**REPORT FOR: CROWE VALLEY CONSERVATION AUTHORITY WATERSHED ADVISORY BOARD**

**REGARDING: ONTARIO REGULATION 159/06, PERMIT APPLICATION NO. 273/22 FOR PERMISSION TO RECONSTRUCT A DWELLING WITHIN THE FLOOD HAZARD.**

**DATE: MAY 4<sup>TH</sup>, 2023**

ZBA 021/22  
328 Trotter Oitment Road  
Grieve & Verduyn  
Part of Lot 10, Con 10  
North Kawartha  
1536 010 100 09500

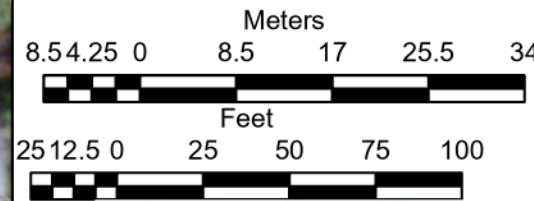
In summary, the Crowe Valley Conservation Authority **has concerns** with this application for a Zoning By-Law Amendment. The proposed development is not believed to be consistent with Section 3.1 Natural Hazards of the PPS as the proposed development is within the flood hazard associated with Chandos Lake.

Based on 30years of daily water levels, the predicted 1:100year flood elevation is 314.30masl. Therefore, all development should be kept a minimum of 6meters from lands on the property that are at or below 314.30masl. 6meters is the provincial standard for emergency access recommended to ensure that people and vehicles have a safe way to enter and

exit the area during times of flooding, including access for emergency personnel and their vehicles across the floodplain and heavy equipment to access the hazard for mitigation purposes. This can be accurately determined by conducting an elevation survey of the property. *The best available data, LiDAR, shows that the proposed development are at or below 314.30masl and would likely be flooded during a 1:100year flood event. There appears to be room on the subject lands for the reconstruction of the dwelling and decks outside of both the 1:100year floodplain of Chandos Lake and 6metre setback from the floodplain.*
